Subject: AP1000 COL Responses to Requests for Additional Information (TR #24)

In support of Combined License application pre-application activities, Westinghouse is submitting responses to NRC requests for additional information (RAI) on AP1000 Standard Combined License Technical Report 24, APP-GW-GLR-060, Rev. 0, Reactor Vessel Insulation System – Verification of In-Vessel Retention Design Bases. These RAI responses are submitted as part of the NuStart Bellefonte COL Project (NRC Project Number 740). The information included in the responses is generic and is expected to apply to all COL applications referencing the AP1000 Design Certification.

# AP1000 TECHNICAL REPORT REVIEW

From Figure 2.4 in ULPU Configuration V Test Report

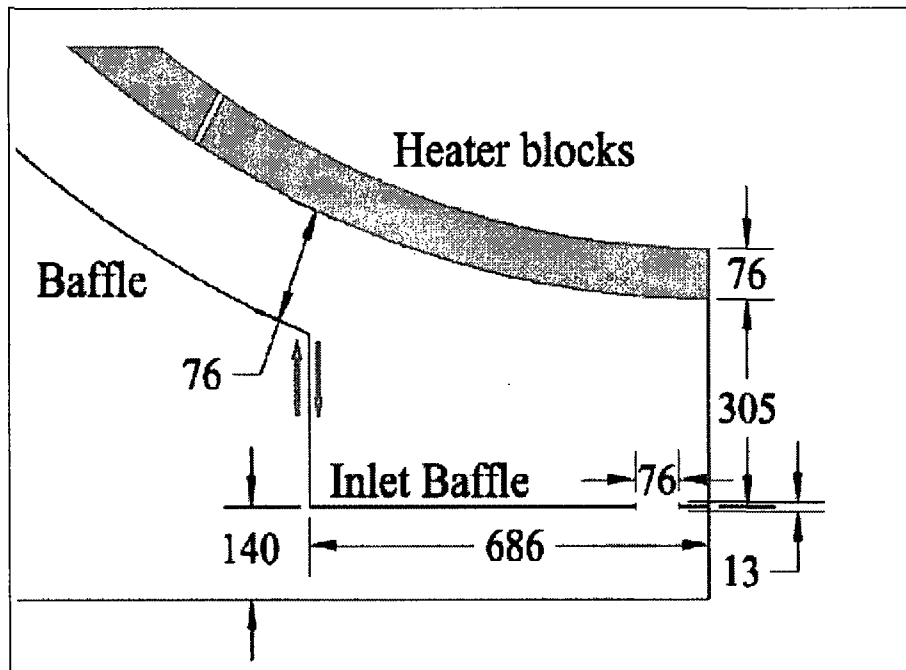
- a) For example, report CRSS-03/06 "Limits of Coolability in the AP1000-Related ULPU-2400 Configuration V Facility" indicates that the inlet baffle is "plugged" during normal operation using floating balls. (The report does not state whether or not such balls were used during the test to check their ability to open the inlet baffle when needed.) However, the proposed design of the Reactor Vessel Insulation System (RVIS) in TR #24 (with elaboration in report APP-MN20-Z0R-001 R0) has been modified to use inlet assemblies with buoyant doors, instead of floating balls.

The figure above is from the ULPU Configuration V test report and shows the test configuration that simulates the inlet assembly. In the test, water entered the inlet assembly through a 76 mm hole in the inlet baffle. The hole was sized to provide a flow area that matched the test scale. The test provides representative IVR results for any inlet assembly design that does not impose a greater flow resistance than the test. A lower flow resistance than the test improves mass flow which enhances in-vessel retention (IVR) performance over that predicted by the test.

The AP1000 design provides a flow area through four doors which exceeds the minimum required area by 33-1/3%. In addition the door design provides a lower flow resistance than modeled in the ULPU Configuration V test.

At the top of the inlet assembly, the bottom head insulation has a circular opening to allow water from the inlet assembly to flow into the annulus between the reactor vessel and the RVIS. The radius of the opening in the insulation panels (686 mm shown in the above figure) is the same for the ULPU Configuration V test and for the AP1000 RVIS design.

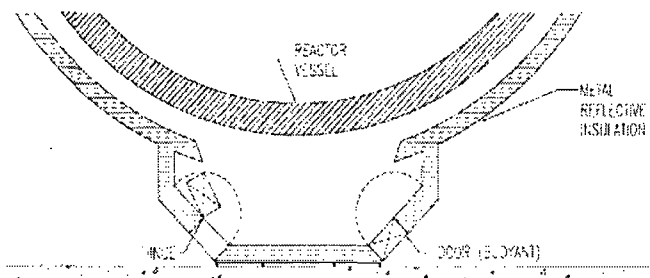
- a) Diagrams in report APP-MN20-Z0R-001 R0 suggest that the inlet assemblies are not at the very bottom of the RVIS structure, but appear to be located some number of degrees of arc away from the very bottom, side-by-side, circumferentially around the structure. The buoyant doors appear to be hinged “on top”, such that the incoming water is expected to force them open in an upward swinging motion.

When the water that enters the annulus makes initial contact with the RPV, it is conceivable that there could be a significant amount of flashing to steam which could locally pressurize this region of the annulus. Because of the way the doors are hinged to “swing upward”, it appears that the local pressurization could be felt “behind the doors”, and possibly impose a closing force on them, which may or may not be greater than the buoyant force trying to open them. The net force calculations in APP-MN20-Z0R-001 R0 did not appear to consider this potential “dynamic backpressure”.

Please provide analytical and/or experimental evidence that the inlet doors, as currently configured will still open sufficiently to provide the required flow area cross-section as specified in APP-GW-GLR-060, given the above potential dynamics.

The hopper has flat sloping sides and each side has one door. The doors are spaced so that no door impedes the action of another. The doors are buoyant and therefore float open with water rising in the reactor cavity during an accident. Water pressure or momentum from inward flowing water is not required to open the doors. The following figure from Reference 1 provides a pictorial.

For clarity, this pictorial only shows two of the four doors. For reference purposes, the door on the right is shown closed and the door on the left is shown in its open position due to buoyancy. All doors would normally be in the same degree of openness.

The center of gravity of the open door is at the intersection of the dashed diagonal lines connecting opposite corners of the door. The center of buoyancy of the doors is in the same location as their center of gravity. In the open position due to buoyancy alone, the center of gravity of each door is over its hinge. The door reaches this position well before the water level reaches the reactor vessel bottom head.
